North Rainier Park Development

Meeting Summary

This was the Seattle Design Commission's (SDC) first review of the North Rainier Park Development. The purpose of this meeting was to review the concept design phase for the project. After the presentation and discussion, the SDC voted, 8-1, to approve the concept design for the North Rainier Park Development with several conditions and recommendations.

Concept Design

Figure 2: Options 2 (left) and 3 (right)

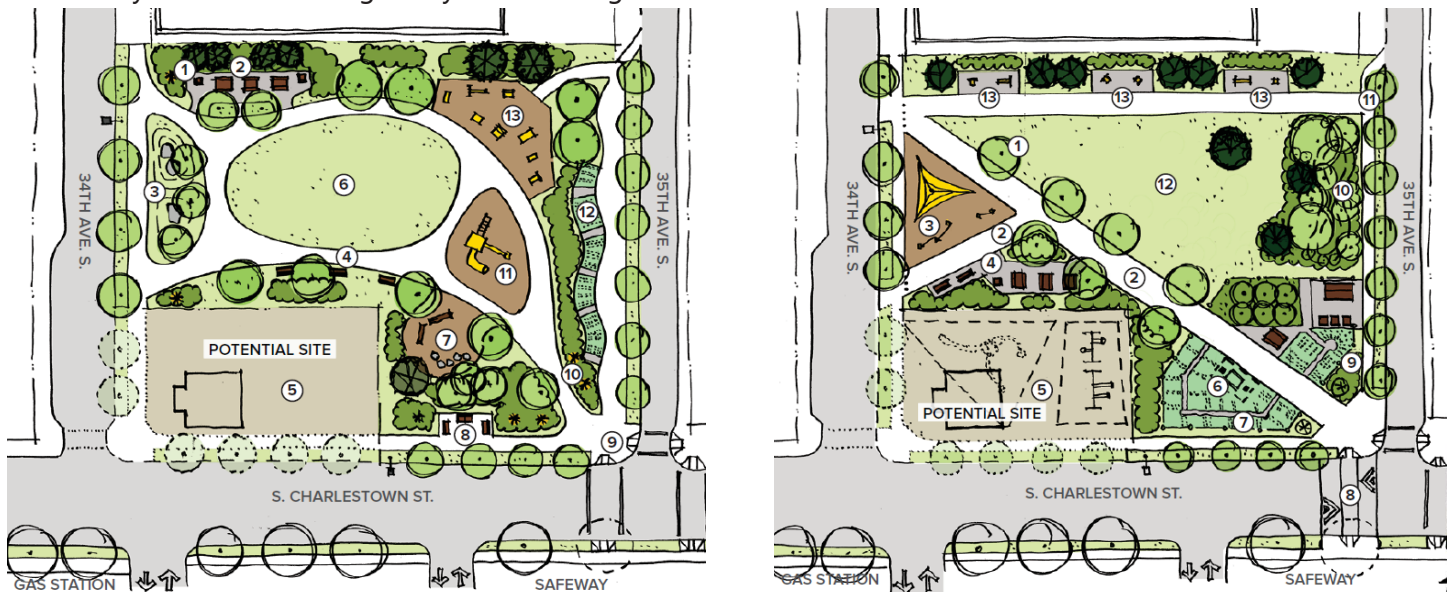
The SDC provided limited comments on the concept design proposals. Commissioners acknowledged the difficulty of providing a strong concept design without knowing if the southwest corner parcel will be acquired. The commission recommended the project team provide a full area concept design that included the southwest corner parcel. The commission also recommended the project team include a hierarchy of pathways throughout the park. Commissioners then encouraged the project team to include a mid-block crossing along S. Charlestown St. and to not let police access direct the design proposal.

1. Provide a site concept design that includes the southwest corner parcel
2. Create a hierarchy of pathways through the park
3. Consider including a sun shade structure within the park design
4. Explore locating the play area near the picnic area
5. Provide sustainability features that contribute to the resiliency of area
6. Update SDC on fundraising for the park development
